MEMORANDUM

Re: PLNPCM2020-00222 – Izzy South Design Review
PLNPCM2020-00655 – Izzy South Special Exception

PROPERTY ADDRESS: 534 East 2100 South
PARCEL ID: 16-19-227-005-0000
MASTER PLAN: within Sugar House and adjacent to Central Community
ZONING DISTRICT: Community Business (CB)

REQUEST: Ryan McMullen requests Design Review and Special Exception approval to construct a mixed-use retail building with 71 dwelling units at approximately 534 East 2100 South within the Community Business (CB) zoning district. Design Review approval is needed because the project is larger than 15,000 square feet in size. The Applicant has requested Special Exception approval to allow an additional 3' (10%) of building height to accommodate the peaked roof structure. The maximum height permitted in the CB zone is 30' and the proposed building would be 33' in height.

EAST ELEVATION | UINTA GOLF

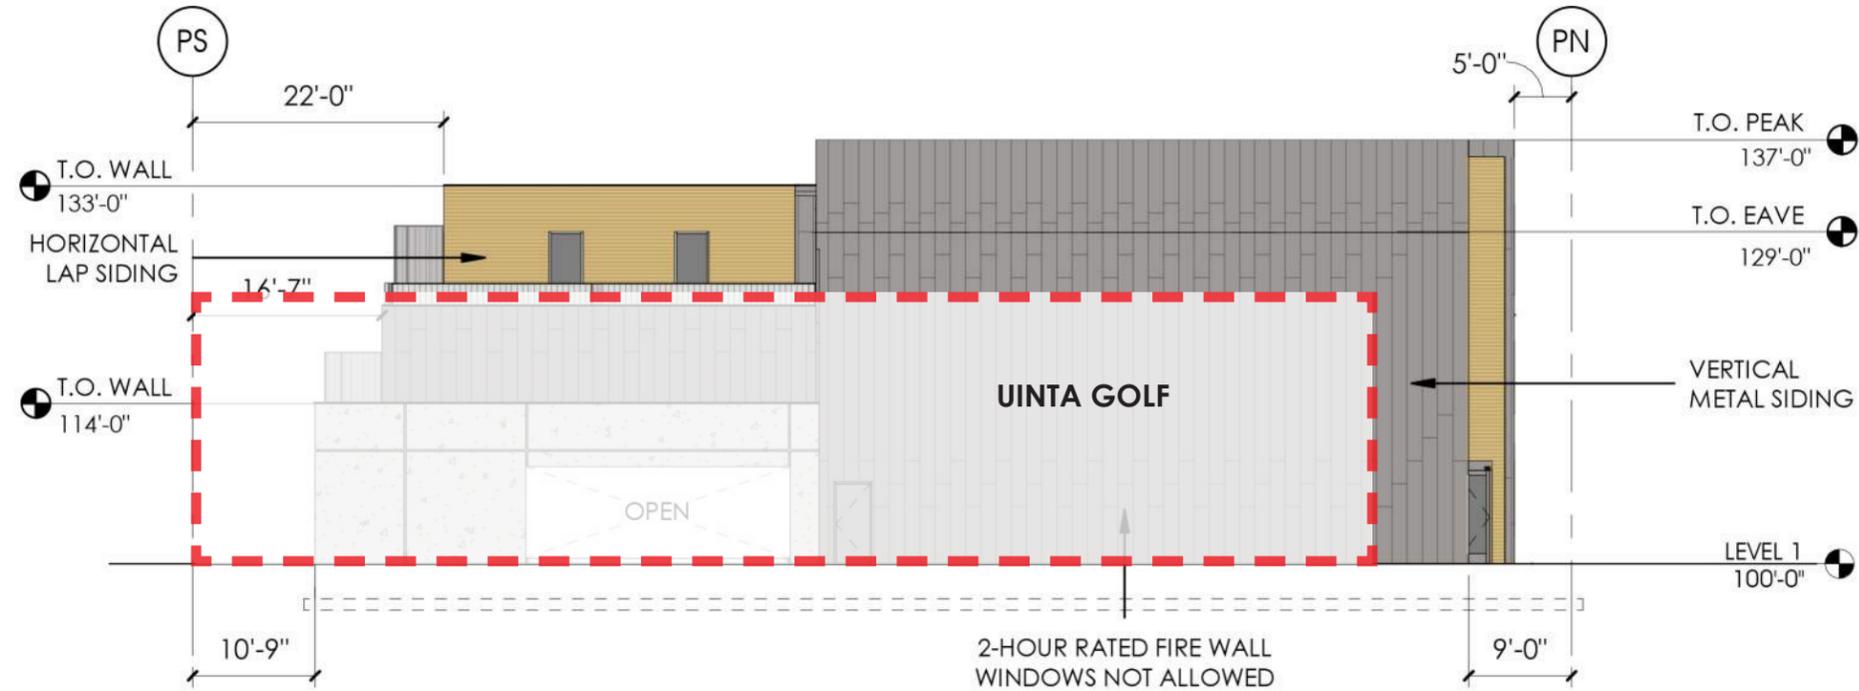
- **Building Massing Adjacent to Neighborhood** – The Planning Commission voiced their concern over the original step-backs of the upper levels of the project indicating they still towered over the single-family neighborhood to the south. The original design included a step back of the second and third levels of the same depth with some units on the second level having balconies over the parking garage. The second and third floors were set back approximately 18' 5" in the original design. The Applicant has since revised this design to step the second floor 16' 7" and the third floor 22' back from the southern (rear) property line to reduce the sense of the height of the building as seen from the single-family backyards to the south.

- **Western and Eastern Facades** – The Planning Commission expressed concern regarding the plainness of the western and eastern facades of the Izzy South project. The proposed Izzy South building would be the tallest building among the abutting properties and the Planning Commission recommended adding some architectural features or other treatment to beautify these blank facades which would be visible from 2100 South. The Applicant has incorporated additional horizontal lap siding along the rear halves of the eastern and western facades which adds variety to the building materials on these faces. This wooden lap siding is the same found on the front façade of the project.

- Additional terracing / setbacks
- Additional material transitions
- Additional detailing with handrails and privacy screens between tenants

- Additional detail added to landscaping
- 2-Hour Fire Rated building separation does NOT allow windows or penetrations
- Adjacent Commercial Building (Uinta Golf) covers this building elevation

ATTACHMENT B:
UPDATED IZZY SOUTH LANDSCAPING
PLAN

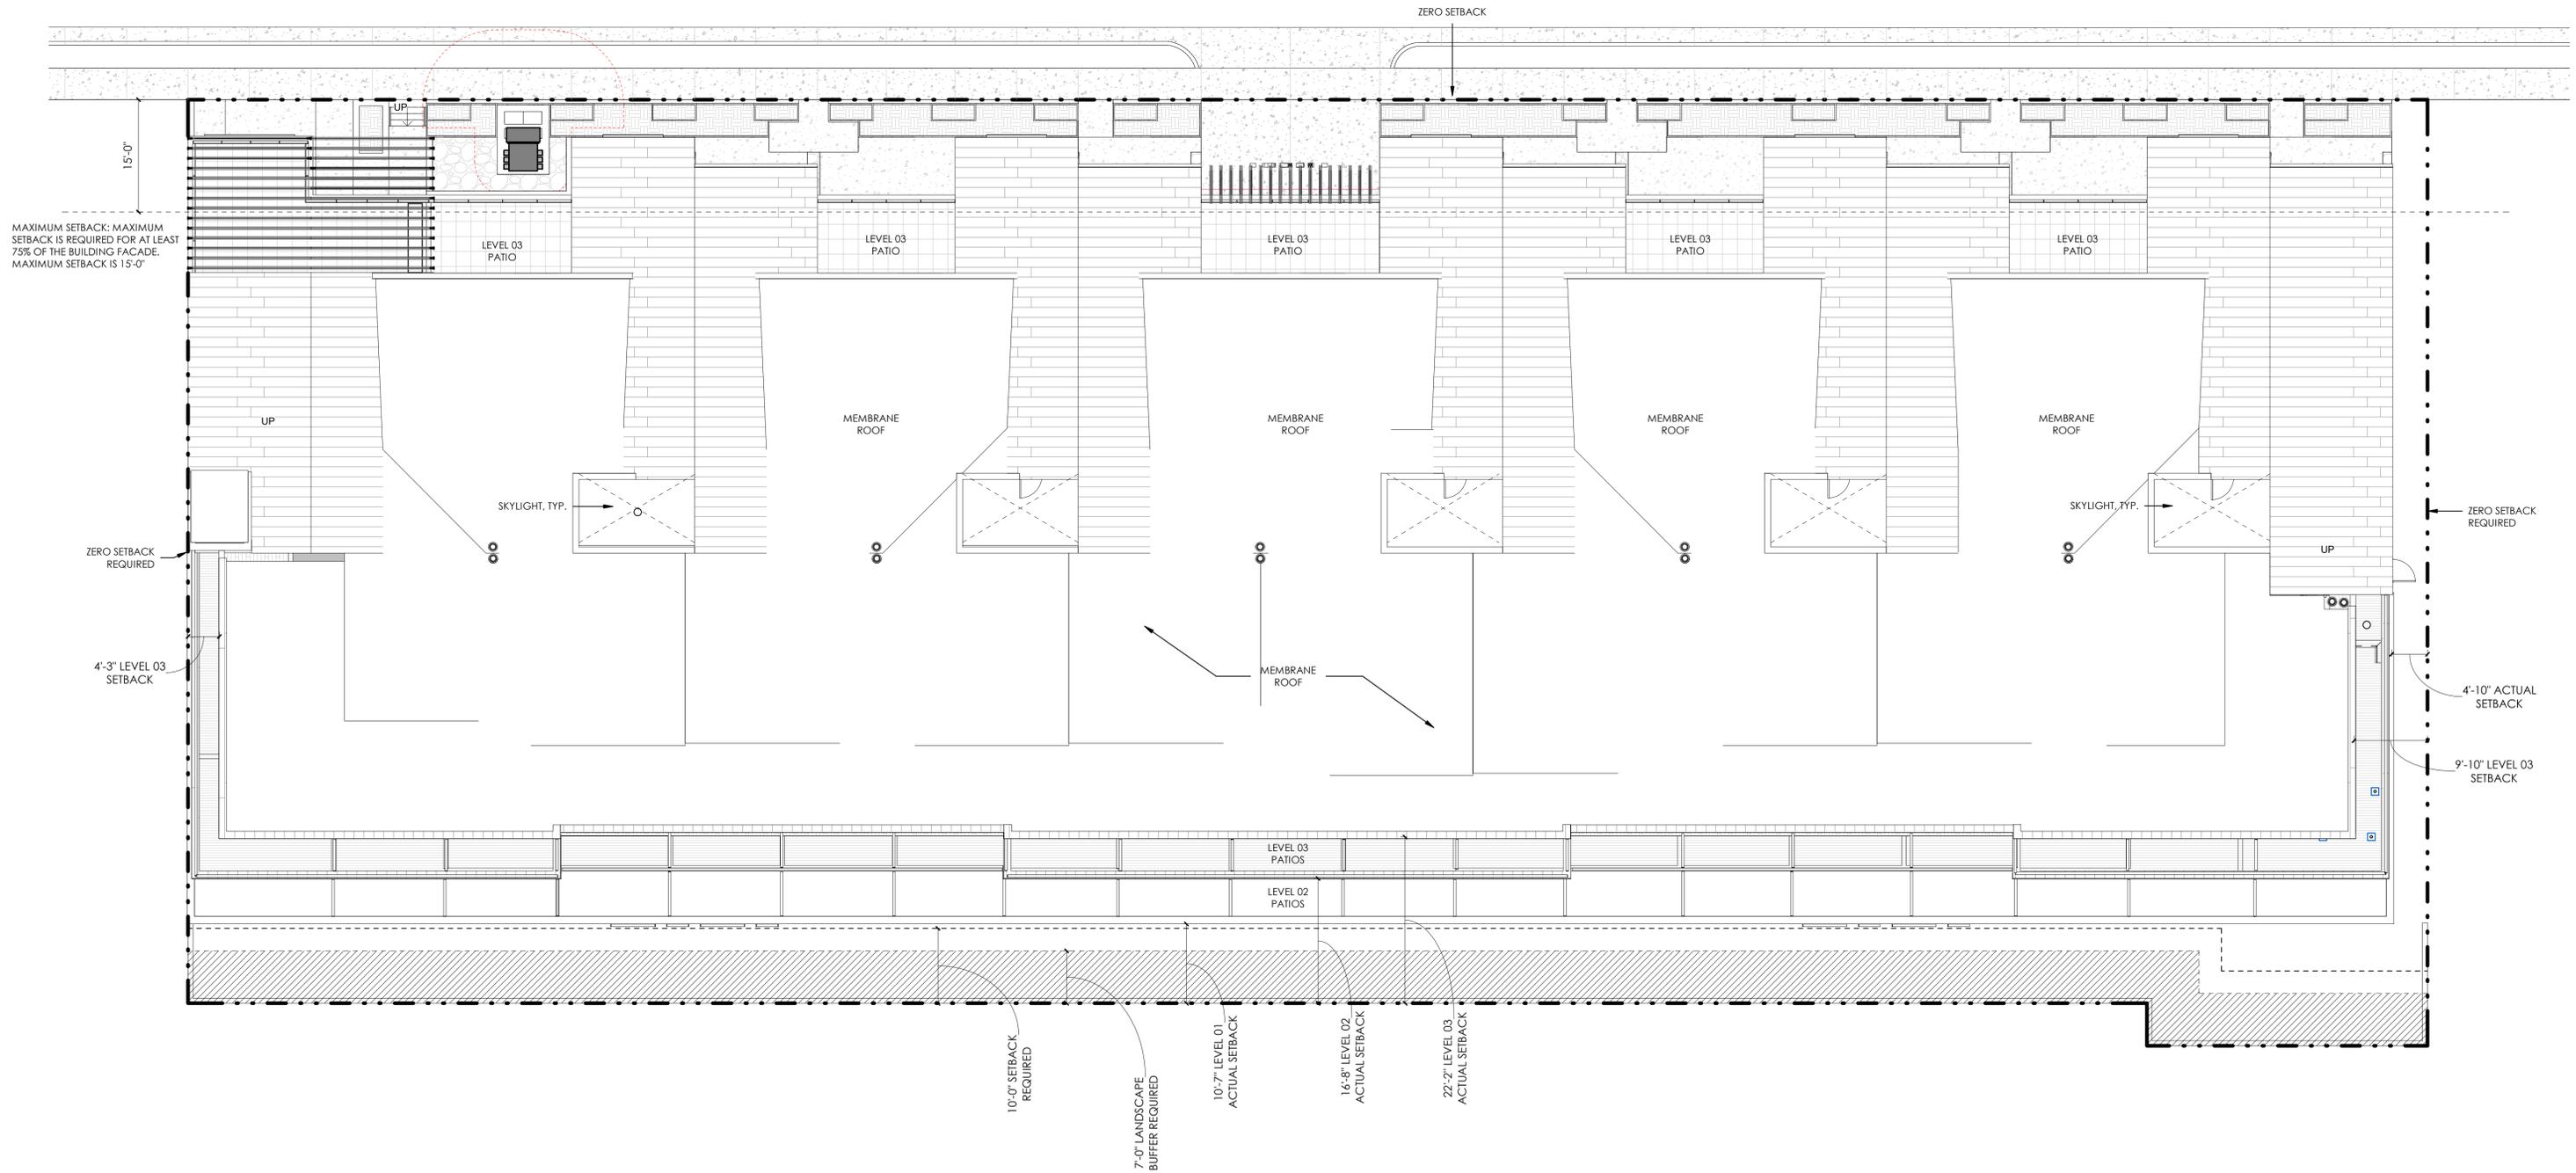
- **Preservation of Neighbors' Privacy** – One of the primary concerns brought up by the members of the public in attendance at the hearing was the preservation of their backyard privacy. The neighbors worried that the upper levels of dwelling units would be able to look directly into their private yards and requested the construction of a 12' tall concrete wall as a condition of approval. The Applicant indicated at the hearing they were open to constructing a privacy wall at the rear of the development to mitigate the neighbors' concerns but would have to request an additional special exception to build a wall in excess of 6'; the maximum rear yard fence height allowed in the CB zoning district. The Applicant has included the requested 6' privacy wall in the updated project renderings. Planning staff does not support a fence or wall taller than 6'.

- **"Neighbor Space" Patios** – The Planning Commission recommended the Applicant add some features to the ground floor patios along 2100 South to help delineate the private patios from the public right of way. The Applicant has included the installation of planters between the private patios and the public sidewalk to establish a "neighbor space" area—a semi-private transition that promotes casual observation of the public sidewalk and defined separation of the public and private realms. These planters will be 5' long, 2.5' wide and 2.5' tall and will be located at the rear of the public sidewalk on the subject property. These planters will increase the amount of landscaping out front of the Izzy South project and will provide privacy to the tenants as they utilize the patio spaces. The Applicant's landscape architect has selected plant species which are acclimated to the local climate and which grow well in container spaces.

The Applicant has also included a shallow landscaped yard along the rear property line where they will plant a species of columnar trees which, at their mature height, will provide a seasonal screen from even the top floor units. Phases of the growth of these trees is shown in the Applicant's updated renderings as well showing height at planting, height at adolescence, and height at maturity.
